# **Pentium® II Processor Specification Update**

Release Date: February 1999

Order Number: 243337-023

The Pentium® II processor may contain design defects or errors known as errata which may cause the product to deviate from published specifications. Current characterized errata are documented in this Specification Update.

**Figure 1. UP Dual Ended Termination (DET)**

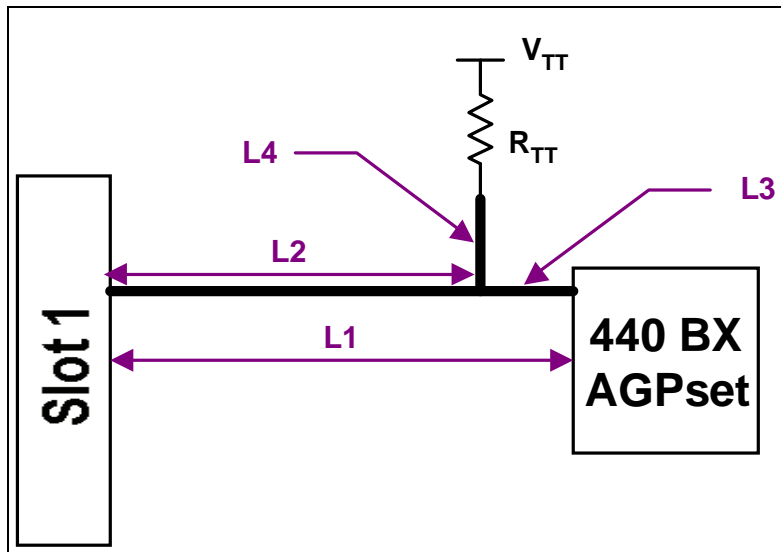
For UP-DET topologies (see Figure 1), the trace length L1 must be between 1.5" to 4.5" while using a 56Ω termination resistor.

**Figure 2. DP Dual Ended Termination (DET)**

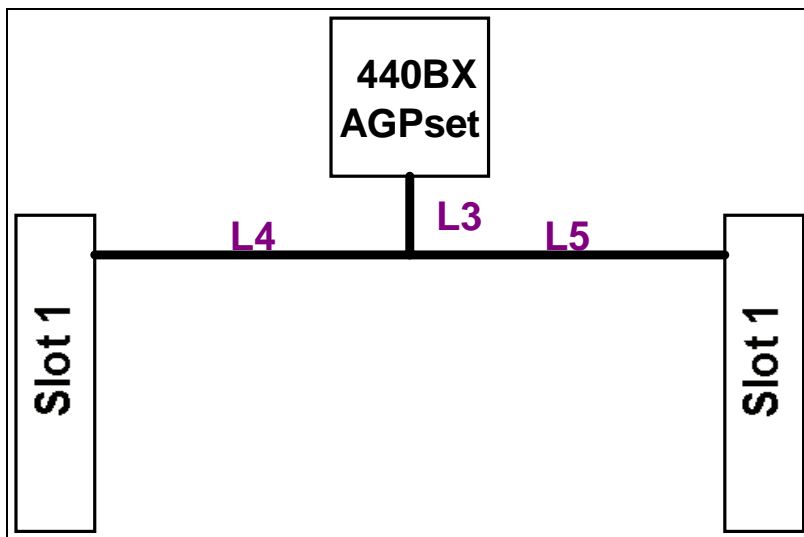
For DP topologies (see Figure 2) installed with a processor and a termination card,  $L4 + L3$  or  $L5 + L3$  must be less than or equal to 4.5". Additionally, for DP platforms with one processor installed, the termination card should be placed in the longer leg.

**Figure 23. Processor with an Example Low Profile Heatsink Attached Using Spring Clips**

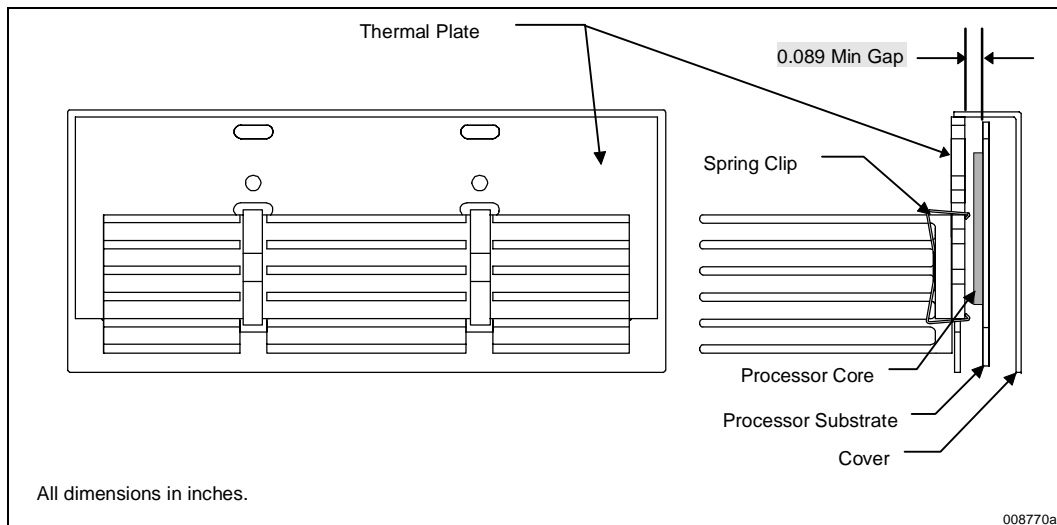
Figure 23 and Figure 24 illustrate example clip designs to support a low profile and a full height heatsink, respectively. The clips attach the heatsink by engaging with the underside of the thermal plate. The clearance of the thermal plate to the internal processor substrate is a minimum **0.089"** (illustrated in Figure 23 and Figure 24). The clips should be designed such that they will engage within this space, and also not damage the substrate upon insertion or removal. Finally, the clips should be able to retain the heatsink onto the thermal plate through a system level mechanical shock and vibration test. The clips should also apply a high enough force to spread the interface material for the spot size selected.

**Figure 26. Heatsink Rivscrew\* and Thermal Plate Recommendations and Guidelines**

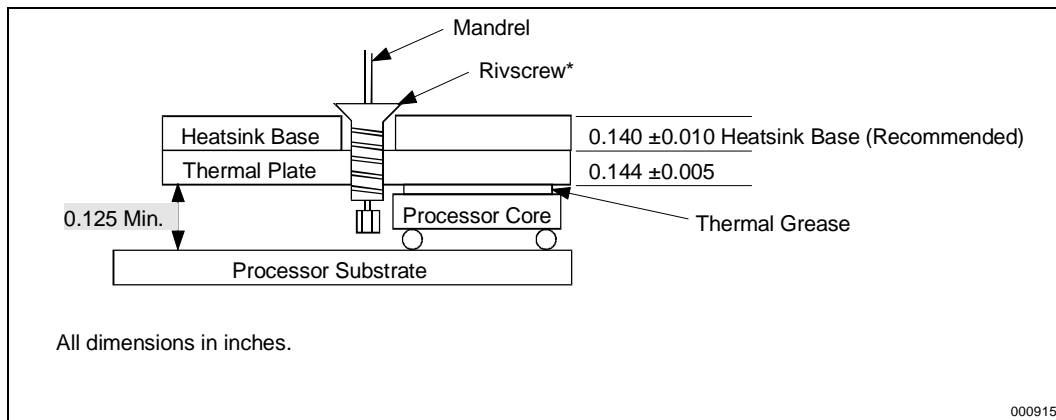
The Rivscrew attach mechanism uses a specialized rivet that is inserted through a hole in the heatsink into the thermal plate. Upon insertion, a threaded fastener is formed that can be removed if necessary. For Rivscrew attachment, the minimum gap between the thermal plate and the processor substrate is **0.125"**. For use of the Advell Rivscrew (part number 1712-3510), the heatsink base thickness must be  $0.140 \pm 0.010"$ . See Figure 25, Figure 26 and Figure 27 for details of heatsink requirements for use with Rivscrews.

**Figure 6. BCLK to Core Logic Offset**

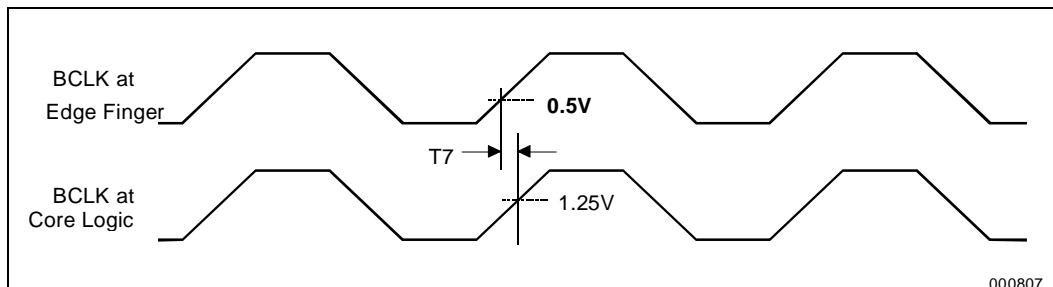
In Figure 6 of the *Pentium® II Processor at 233 MHz, 266 MHz, 300 MHz, and 333 MHz* datasheet, the following changes should be made:

**Figure 7. BCLK\*, PICCLK, and TCK Generic Clock Waveform**

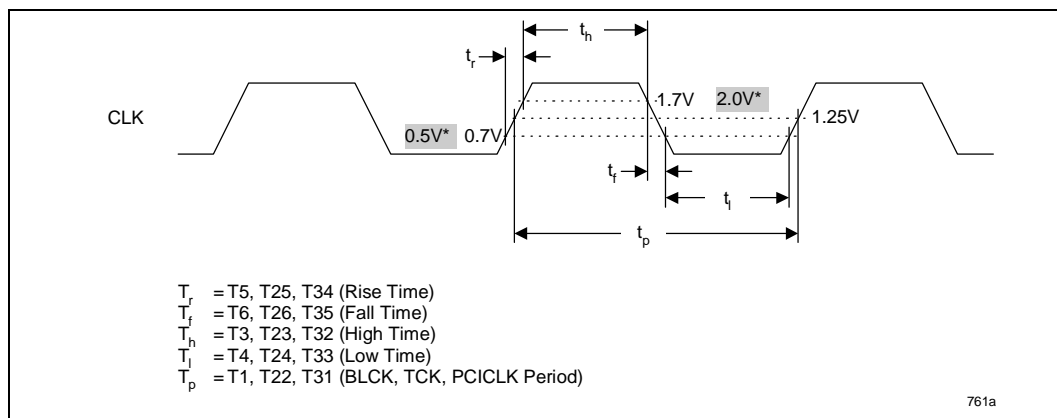
In Figure 7 of the *Pentium® II Processor at 233 MHz, 266 MHz, 300 MHz, and 333 MHz* datasheet, the following changes should be made:
